**PROPOSED RESIDENTIAL DEVELOPMENT
24-25 SOUTH ESPLANADE, GLENELG (APP ID: 25039981)**

I refer to the proposed residential apartment development at 24-25 South Esplanade, Glenelg. As requested, I have reviewed the Request for Information (RFI) received from the City of Holdfast Bay (Council) and provide the following comments in respect to the traffic and waste related queries.

Figure 1 - Proposed ramp and 1:20 gradient ramp cross sections

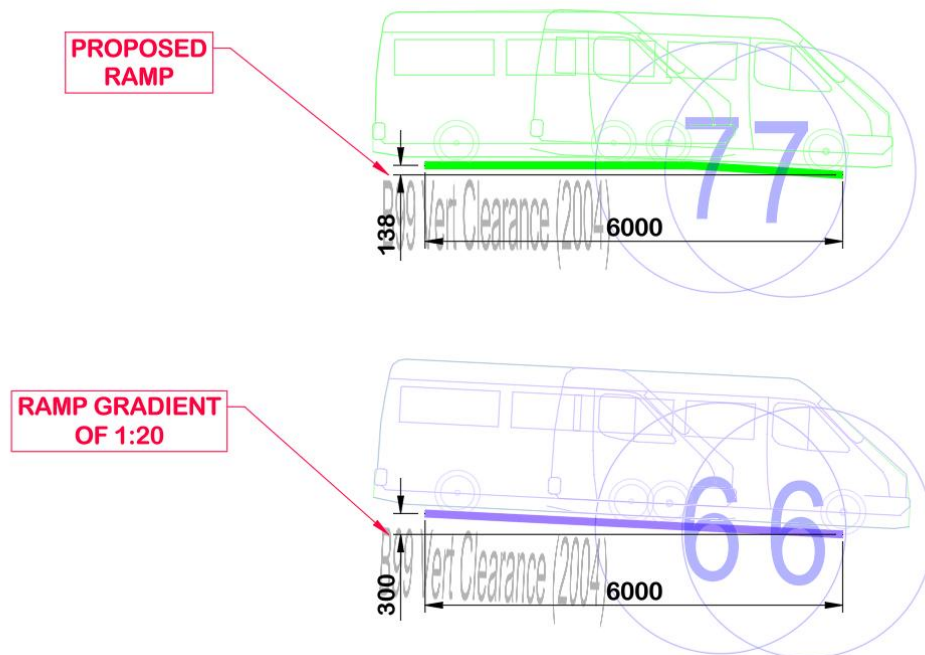
"The applicant continues to assert that the 3.79 m storage length is adequate based on assumed vehicle wheelbases; however:

- This is inconsistent with the intent of the Australian Standards with respect to safe queue storage.*
- Reliance on the 1:16 transition to achieve an assumed effective storage length introduces operational uncertainty, including driver behaviour variability and reduced vehicle control on gradients."*

The top of the basement parking ramp (at the site's access) comprises a section 3,794 mm long at grade followed by a subsequent section at 1 in 16. In respect to AS/NZS 2890.1:2004, the 1 in 16 section is within the first 6 m of the ramp at which a maximum 1 in 20 grade is required. However, taking the cross section of the proposed ramp, the ramp is effectively at a lesser gradient than a ramp at 1 in 20 for the first 6 metres. Figure 1 illustrates the cross sections of the proposed ramp and a ramp at 1 in 20.

A vehicle stored at the site's access will be positioned at a lesser gradient when compared to a ramp that is strictly conformant with AS/NZS 2890.1:2004. As such, the ramp is considered safe and appropriate, and will not result in increased operational uncertainty or reduced vehicle control (as suggested by Council).

Figure 3 - 10 m refuse vehicle turn paths adjacent the site

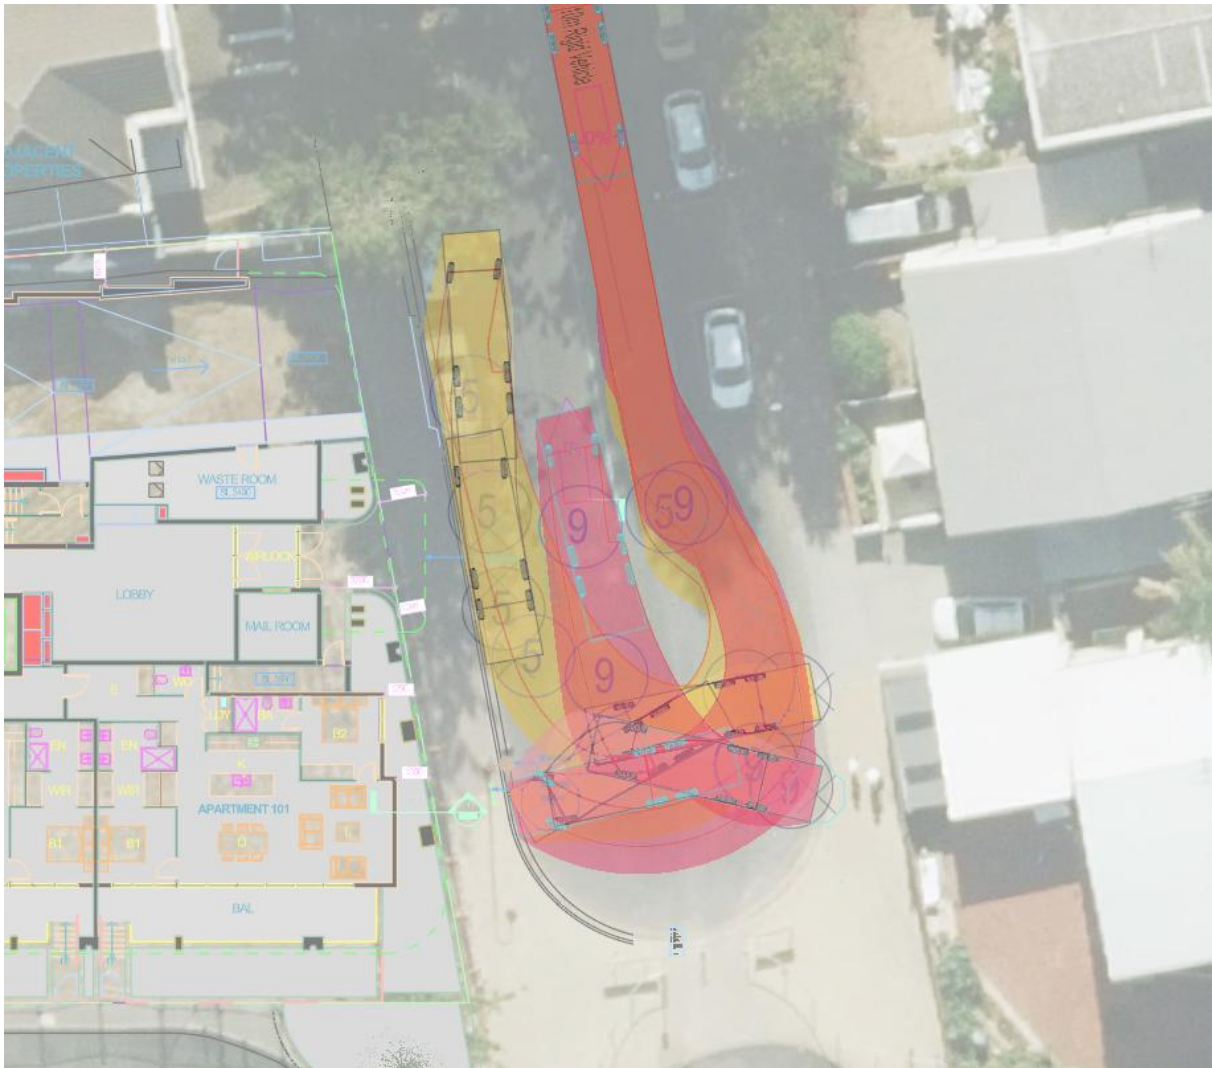
“...could you please confirm the exact location and extent of the proposed loading bay on Pier Street? The current description in the report is somewhat unclear. Based on the drawings provided, it appears that the vehicular access to the car park would displace the

existing marked on-street parking space, and that the loading area may extend further west into the section currently subject to No Stopping restrictions to maintain the turning head.

To assist with our assessment, please provide swept path diagrams demonstrating that the turning head of Pier Street remains functional for service vehicles with the proposed loading zone in place and occupied.

The refuse vehicle turn path is illustrated in Figure 3 below (10 m refuse turn path previous provided in the Traffic and Parking Report by CIRQA).

Figure 3 demonstrates the 10 m refuse vehicle (orange path) is able to access the proposed loading bay adjacent the site's frontage in a 5-point movement (as per the previous approved arrangement). Access to the loading bay has been shown for a larger 10 m vehicle, noting that the previous arrangement adopted an 8.8 m Medium Rigid Vehicle (MRV). Furthermore, Figure 3 demonstrates that the turning head of Pier Street remains functional for service vehicles (up to 10 m) while the loading zone is occupied.
